## Report to the Joint Regional Planning Panel

<b>Application number</b>	DA-203/2014
<b>Site address</b>	30 Wellington Street and 18-22 Ocean Street, Bondi
<b>Proposal</b>	Demolition of existing structures and construction of five residential flat buildings, including basement parking and retention of the heritage listed Scarba House
<b>Date of lodgement</b>	16 May 2014 Amended plans received 21 October 2014
<b>Owner / Applicant</b>	Mirvac Projects Pty Limited
<b>Submissions</b>	Original scheme: 82 submissions Amended scheme: 32 submissions
<b>Cost of works</b>	\$81,265,420
<b>Issues</b>	Height, heritage conservation, transport and parking, excavation, setbacks, building separation, private open space, overshadowing, views and view sharing, visual privacy and security.
<b>Recommendation</b>	That the application be granted a DEFERRED COMMENCEMENT

#### **1.1 EXECUTIVE SUMMARY**

Figure 1: Proposed site plan

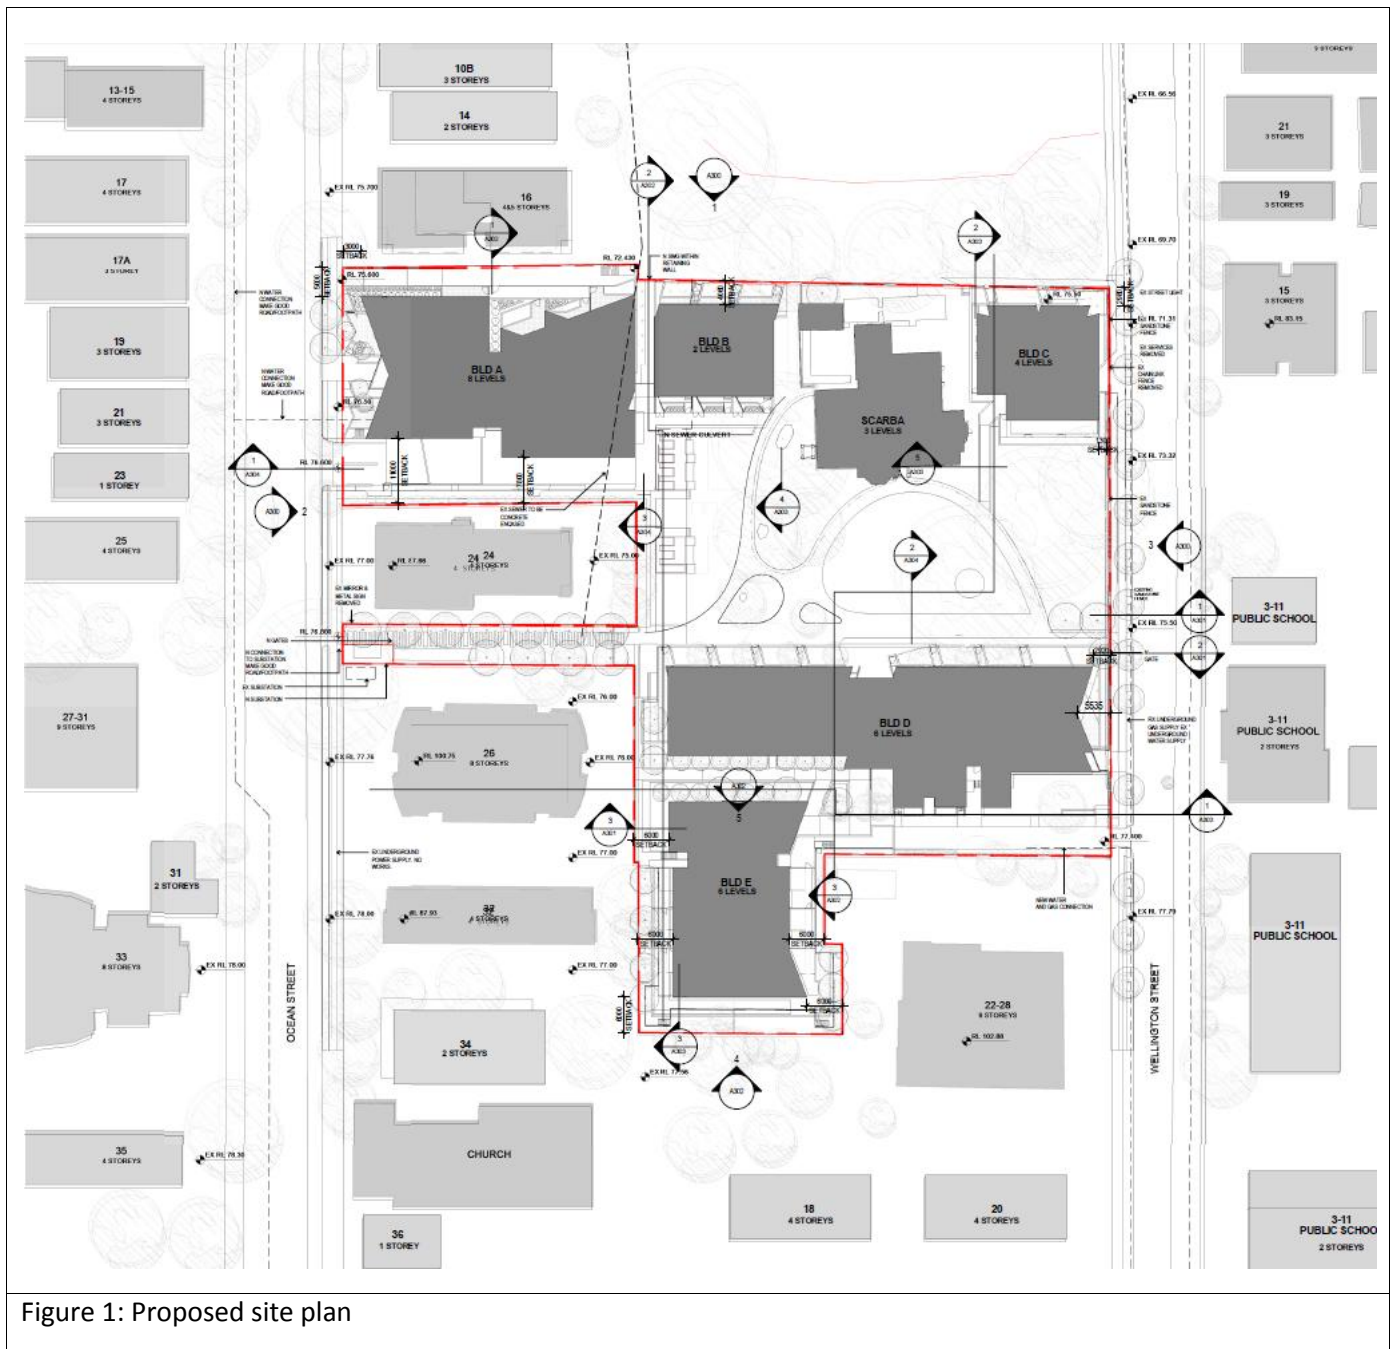
A proposed site plan, indicating the proposed Buildings and surrounding context is provided in Figure 1 below.

The proposal seeks consent for the demolition of the existing structures on the site, with the exception of the heritage-listed Scarba House, and the construction of five residential flat buildings (refer to Figure 1 for proposed site plan).
